Designation: ~~D955-00~~ Designation: **D 955 - 08**

Standard Test Method of Measuring Shrinkage from Mold Dimensions of Thermoplastics¹

FIG. 1 Type D2 (Mold Layout)

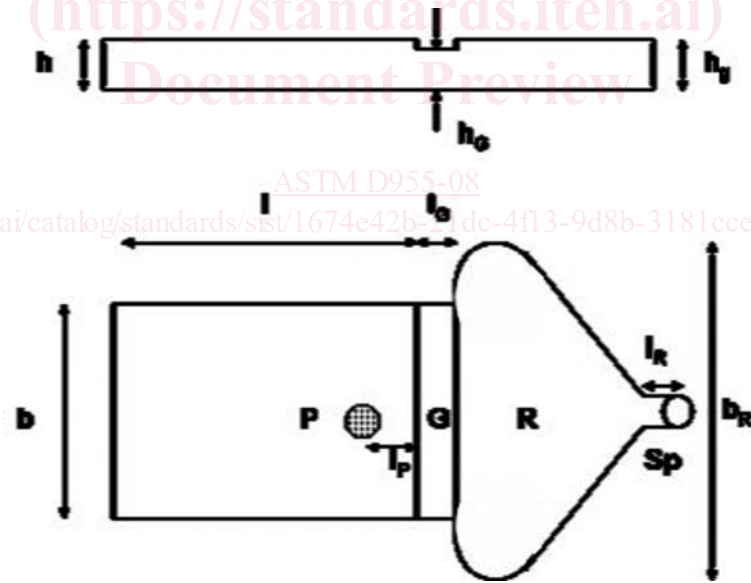
7.1 *Injection Mold*—Specimens shall be molded in a two cavity mold conforming with dimensions as shown in Figs. 1 and 2 for the 60 × 60-mm plaque specimen (Type D2), Fig. 3 for the 12.7 × 127-mm bar specimen (Type A) and Fig. 4 for the 100mm × 3.2-mm disk specimen (Type B). The mold may have scribe marks included for the measurement of shrinkage. The scribe marks shall be 1.0 mm long by .01 mm wide located 1.0 mm from each edge on one side of the mold. Pressure transducers for monitoring the pressure in at least one cavity are mandatory for Type D2. Mold shrinkage measurements should be made on specimens that have been molded at one of the following cavity pressures ± 3% from the selected pressure: 20 MPa, 40 MPa, 60 MPa, 80 MPa, 100 MPa, or as specified in the appropriate material specification. Pressure transducers are recommended, but not mandatory for specimens Type A and Type B. for the 100 mm by 3.2-mm disk specimen (Type B). Pressure transducers for monitoring the pressure in at least one cavity are mandatory for Type D2. Mold shrinkage measurements shall be made on specimens that have been molded at one of the following cavity pressures ± 3 % from the selected pressure: 20 MPa, 40 MPa, 60 MPa, 80 MPa, 100 MPa, or as specified in the appropriate material specification. Pressure transducers are recommended, but not mandatory for specimens Type A and Type B.

FIG. 3 Bar Specimen

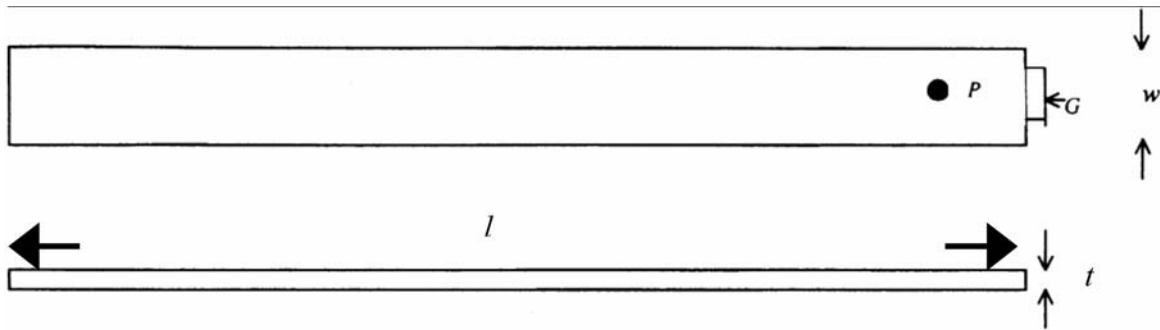
8.1.2 *Specimen Type A*—For shrinkage parallel to flow, a bar mold having a cavity of 12.7 ×by 127 mm ~~may~~shall be used as shown in Fig. 3. The thickness shall be 3.2 mm unless otherwise agreed upon by the seller and the purchaser. The mold shall have at one end a gate 6.4 mm in width by 3.2 mm in depth.

FIG. 4 Disk Specimen

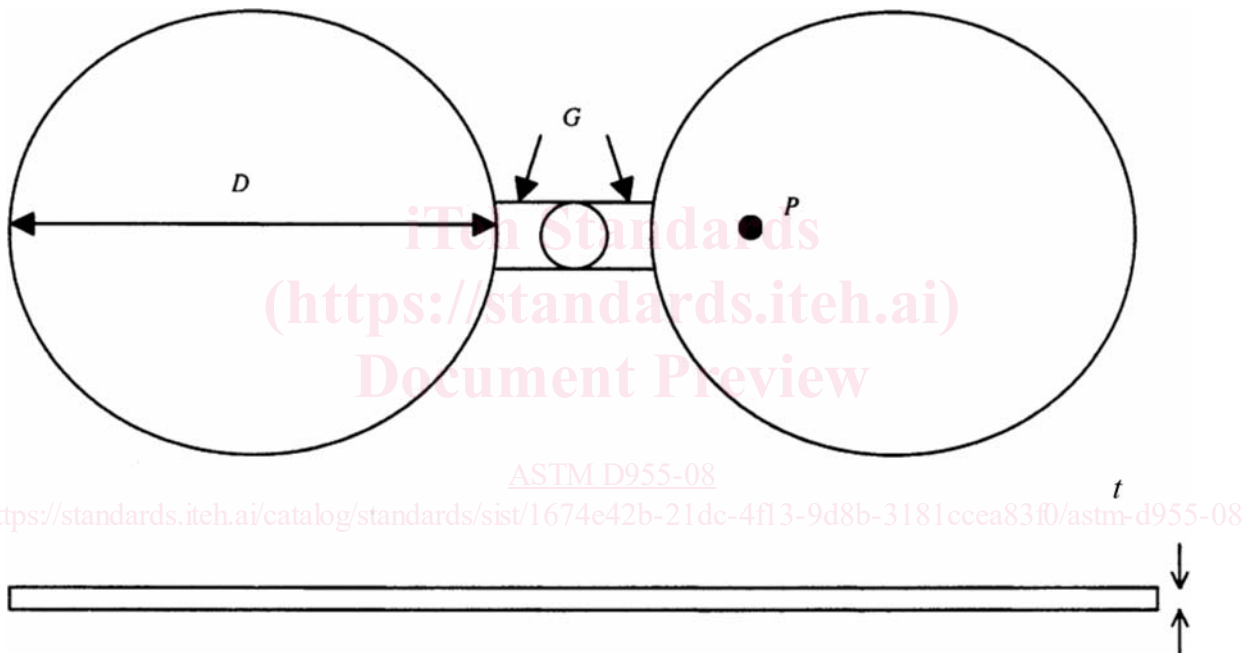
8.1.3 *Specimen Type B*—A disc shaped specimen, as shown in Fig. 4, having a cavity 100 mm in diameter by 3.2 mm in thickness with a gate 12.7 mm in width by 3.2 mm in depth, placed radially at the edge, ~~may also~~shall be used.
